PARTS LIST FOR MODEL SSV3500

MRP Ver 100314
(based on Penn's Rev. 6 10-01-14)

Penn Reel Parts list for Model: SSV3500 Spinfisher V

MRP Ver 032924 (Parts List updated to clarify housing/gearing design changes sizing)

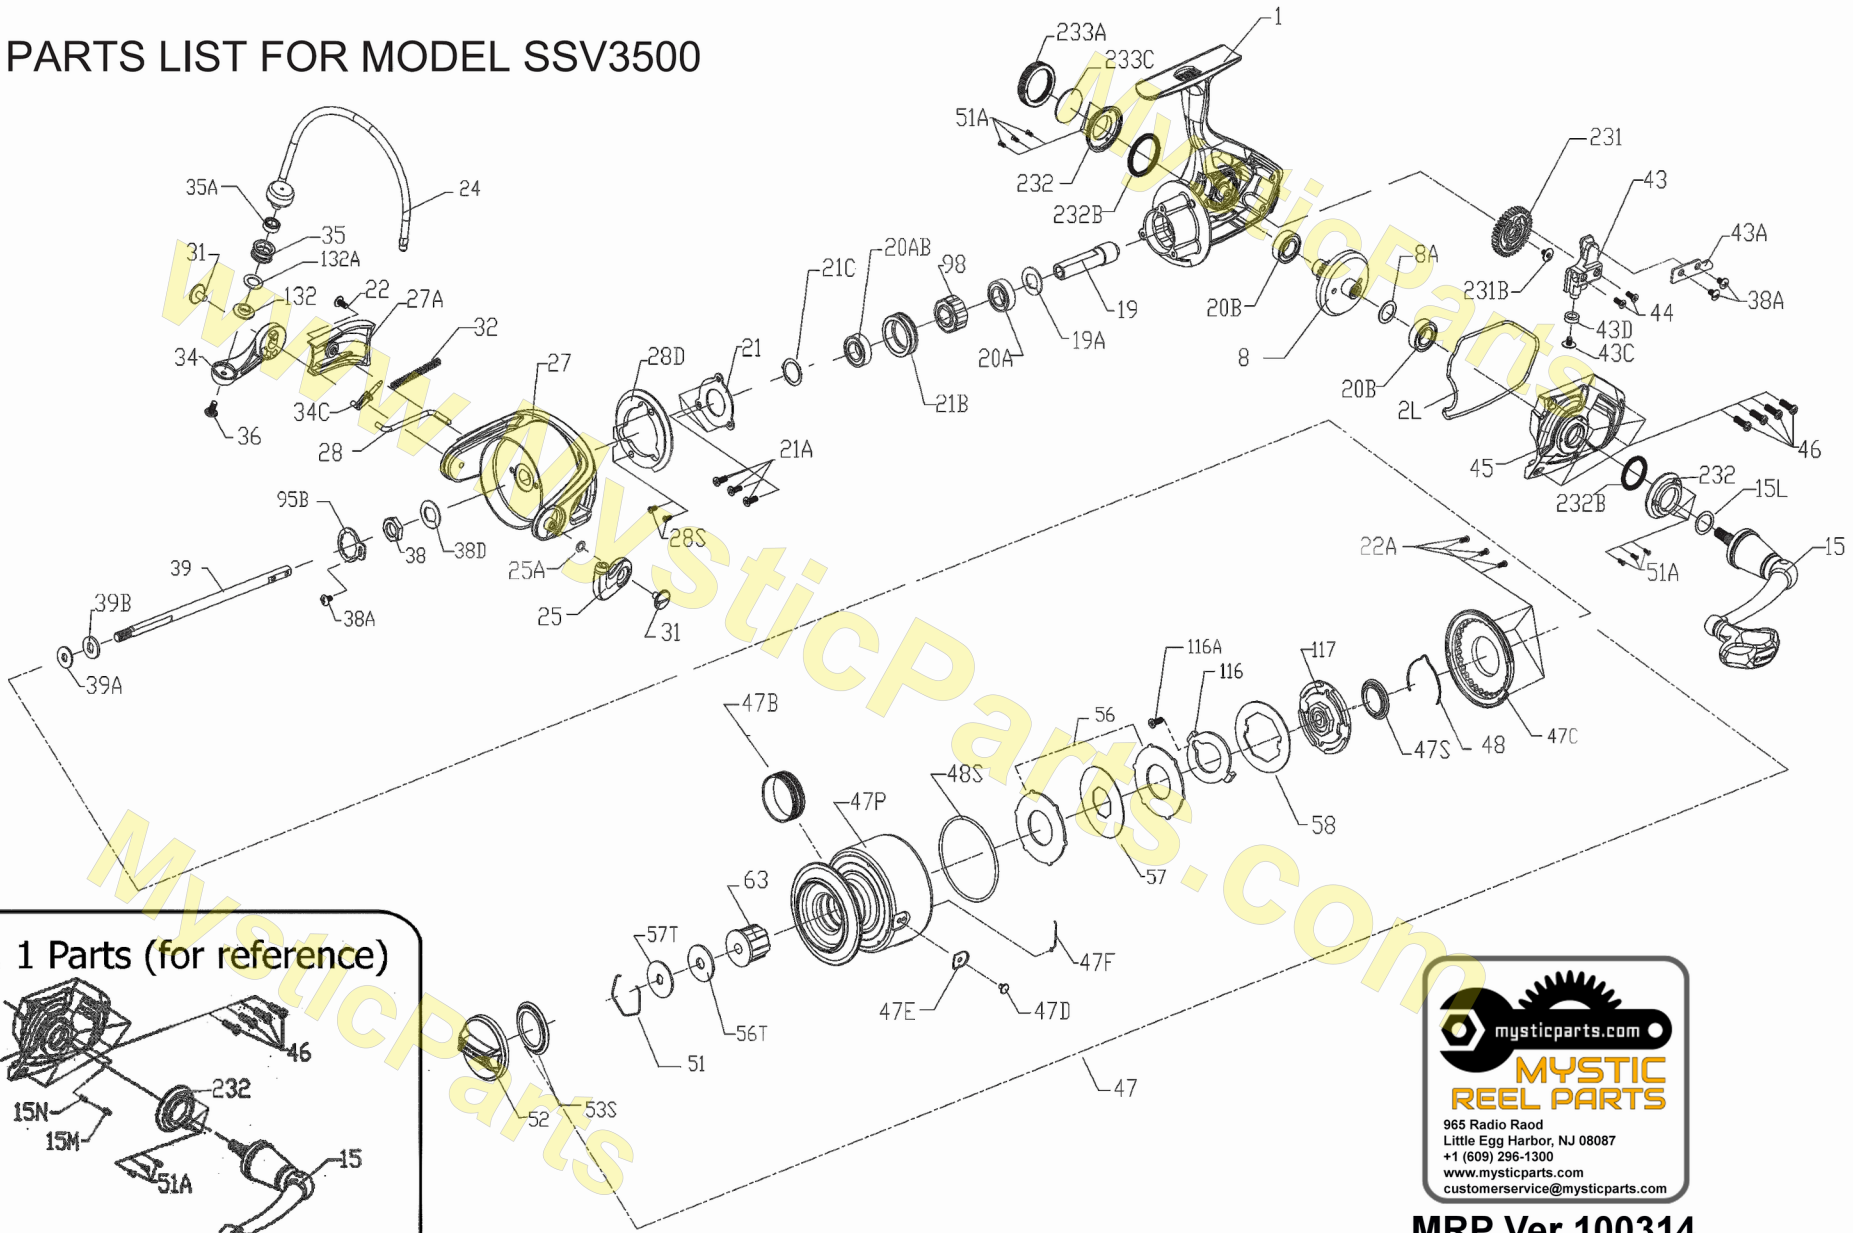
15M,15N REMOVED (NOT PURCHASABLE?)

Rev. 4 CHANGED BEARING INFORMATION ----- >

20A	1276924	20A-SSV3500 BALL BEARING (2 REQUIRED)
		THIS WAS UPPER AND LOWER PINION BEARING
20B	1192619	20B-3000SG BALL BEARING (2 REQUIRED)

We are assuming there were errors with the bearing part numbers on the schematic, rather than that they actually changed the bearings.

Early SSV reels when released had a slightly different housing, crosswind gear and housing cover

The diameter of the CW gear hole and post was CHANGED and the pin/pin hole diameters on the 45- cover were changed as well

THIS DESIGN CHANGE affects the housing, crosswind gear, and housing cover

RECOMMEND TO USE THE REVISION 6 NUMBERS

MEASURE YOUR HOUSING/GEAR

Parts that you order MUST MATCH EACH OTHER

1	1276797	1-SSV3500	HOUSING, BODY ASSEMBLY with .23 peg (1/4")
231	1276968	231-SSV3500	CROSSWIND OSCILLATION GEAR 0.23" I.D. (1/4")
45	1276948	45-SSV3500	HOUSING / BODY COVER to match (1/4")
231B	1307857	231B-SSV3500	CROSSWIND OSCILLATION GEAR SCREW (1/4")

1	NLA **	1-SSV3500	HOUSING, BODY ASSEMBLY with .309 peg (5/16")
231	NLA **	231-SSV3500	CROSSWIND OSCILLATION GEAR 1st run 0.309" I.D. (5/16")
45	NLA **	45-SSV3500	HOUSING / BODY COVER to match (5/16")
231B	1277100	231B-SSV5500	CROSSWIND OSCILLATION GEAR SCREW (5/16")
